HISTORIC AND DESIGN REVIEW COMMISSION

HDRC CASE NO: 2024-279
ADDRESS: 401 KENDALL ST
LEGAL DESCRIPTION: NCB 1744 BLK 12 LOT S 50 FT OF 5 & 6 ARB A-7
ZONING: MF-33
CITY COUNCIL DIST.: 1
DISTRICT: Tobin Hill Historic District
APPLICANT: Shannon Follansbee/KEN 401 LLC
OWNER: Shannon Follansbee/KEN 401 LLC
TYPE OF WORK: Additions and alterations
APPLICATION RECEIVED: August 08, 2024
60-DAY REVIEW: October 7, 2024
CASE MANAGER: Bryan Morales

The applicant is requesting a Certificate of Appropriateness for approval to:

SOUTH LEFT ELEV

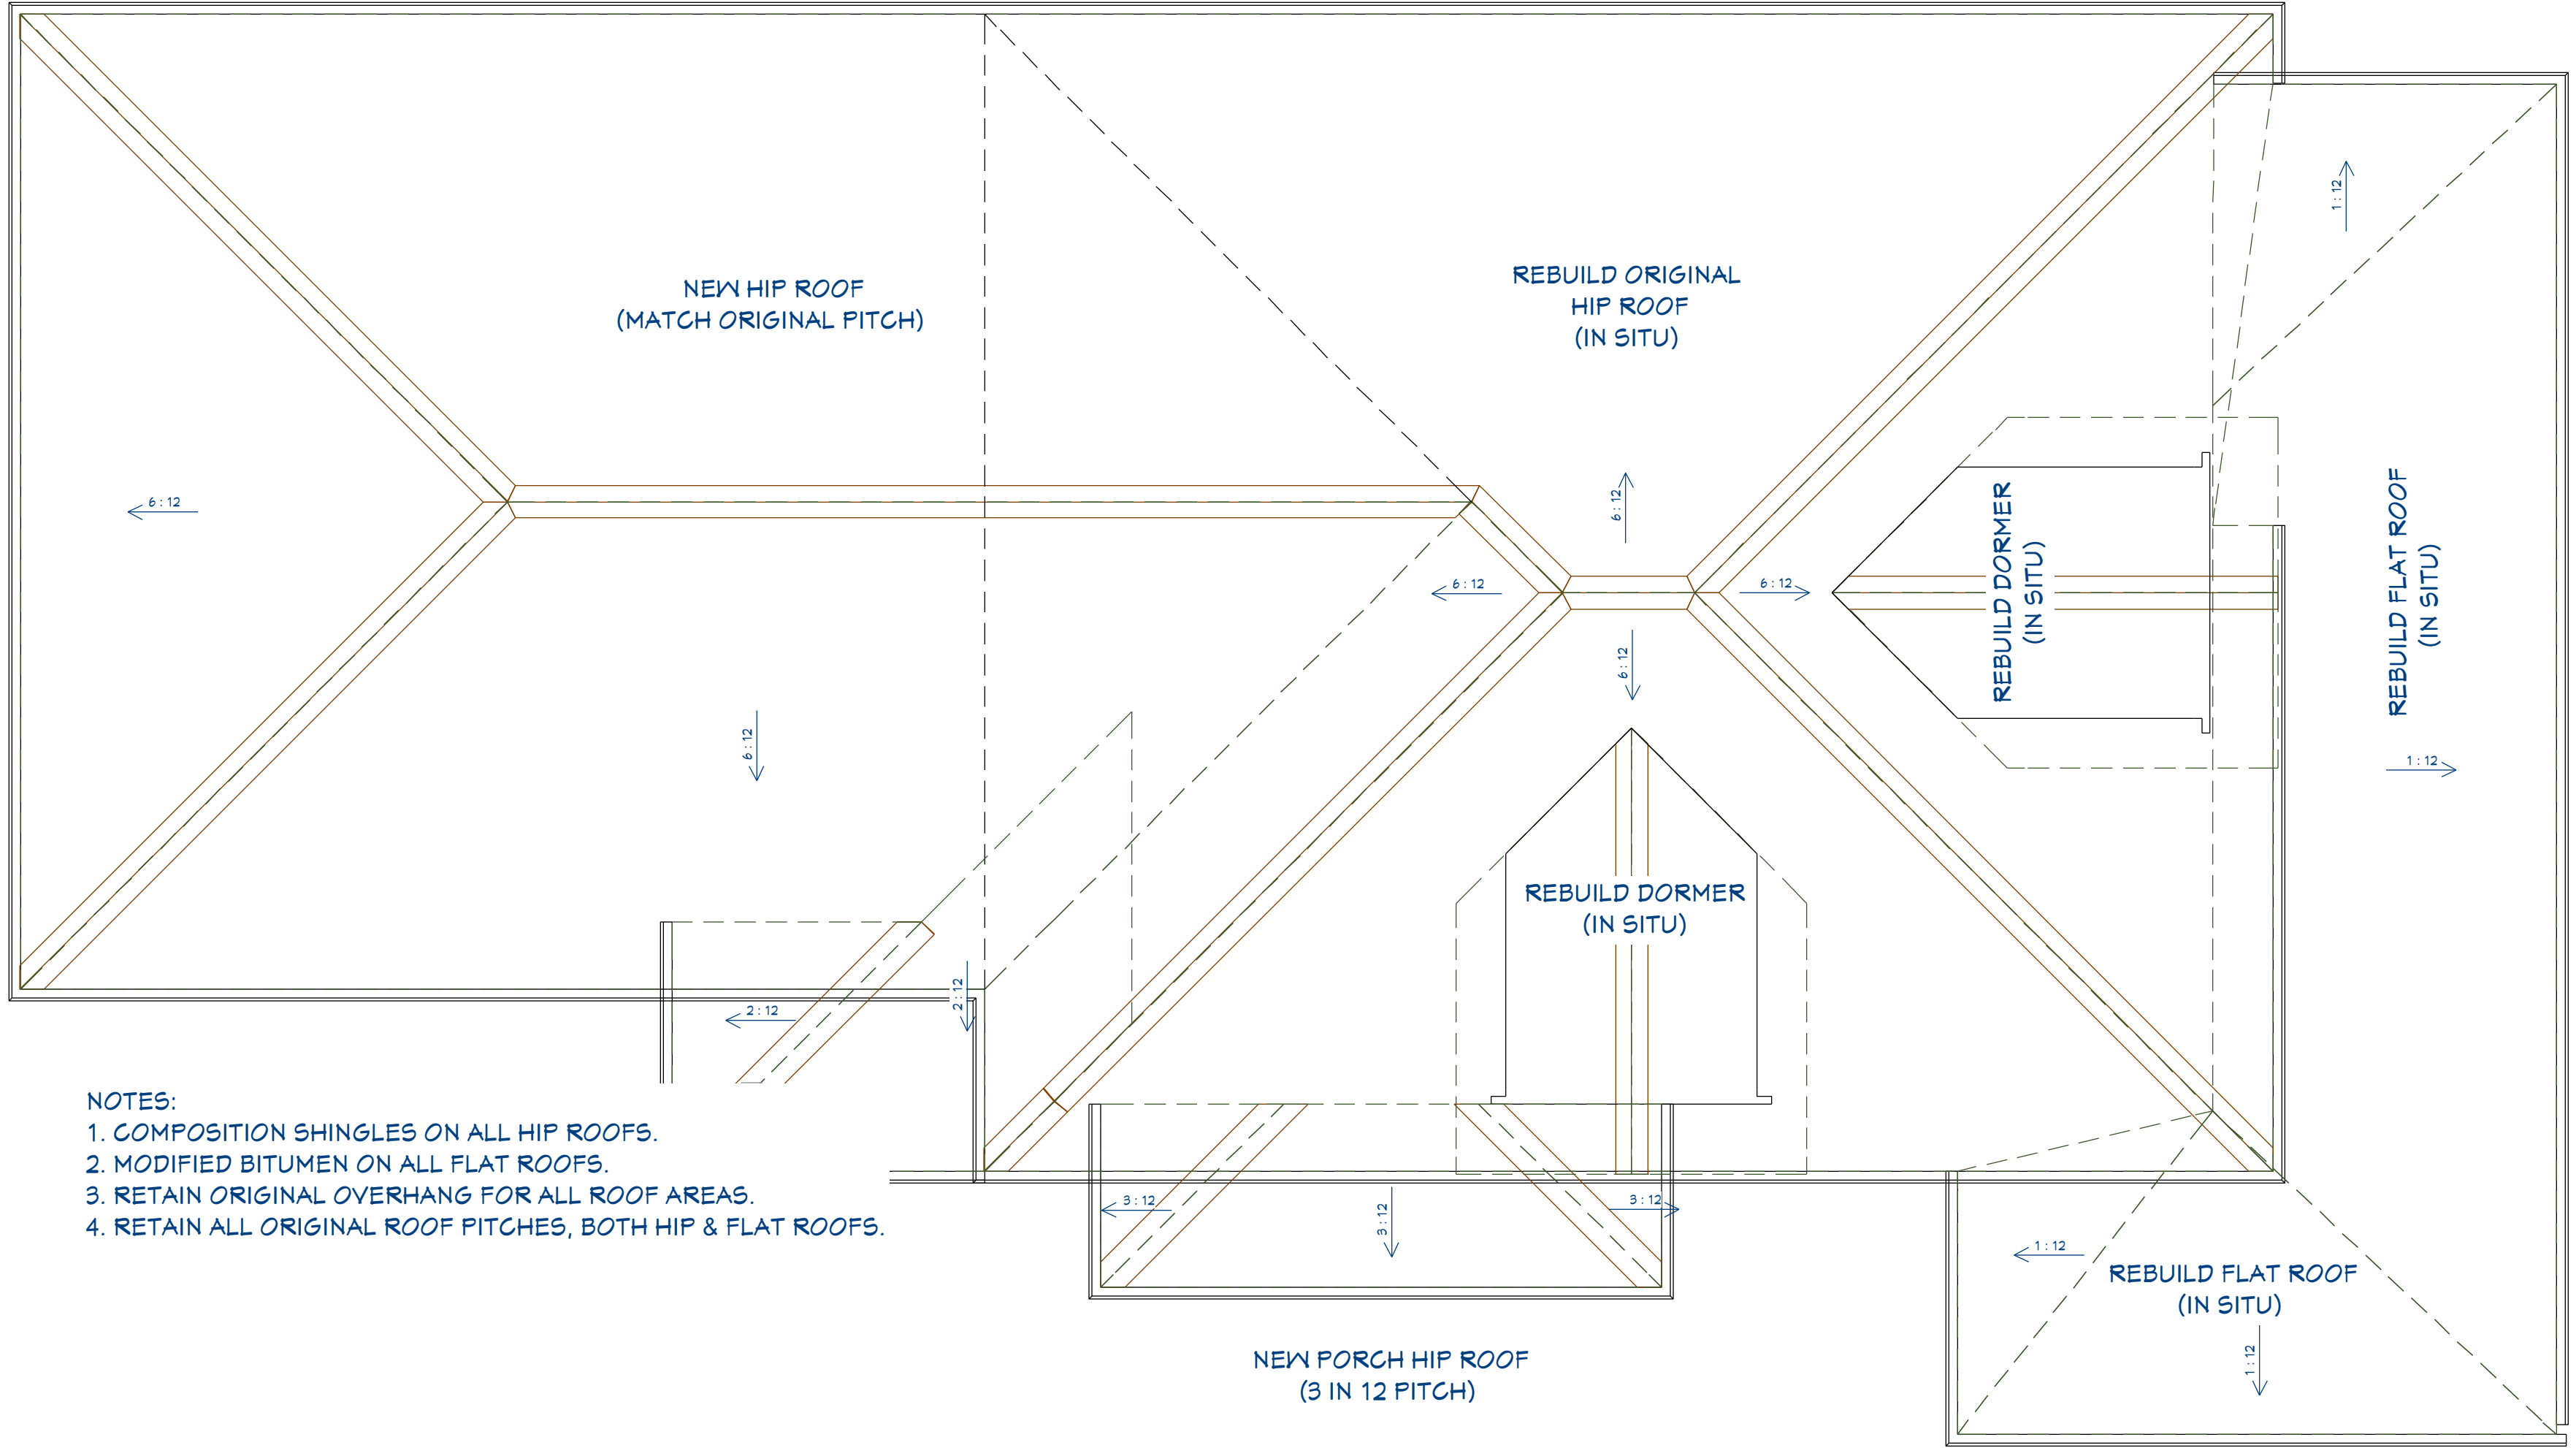
- s. **FENESTRATION MODIFICATIONS (LEFT: SOUTH)** – The applicant is requesting approval to modify the existing fenestration pattern on the left façade to include the removal of one door. Exterior Maintenance and Alterations 6.A.i. states to preserve existing window and door openings, to avoid enlarging or diminishing to fit stock sizes or air conditioning units, and to avoid filling in historic door or window openings. Exterior Maintenance and Alterations 6.A.iii. states to preserve historic windows. Exterior Maintenance and Alterations 6.B.iv. states to install new windows to match the historic or existing windows in terms of size, type, configuration, material, form, appearance, and detail when original windows are deteriorated beyond repair. Exterior Maintenance and Alterations

- 6.B.vii. states to replace non-historic incompatible windows with windows that are typical of the architectural style of the building. Staff finds the proposed fenestration modifications generally appropriate.
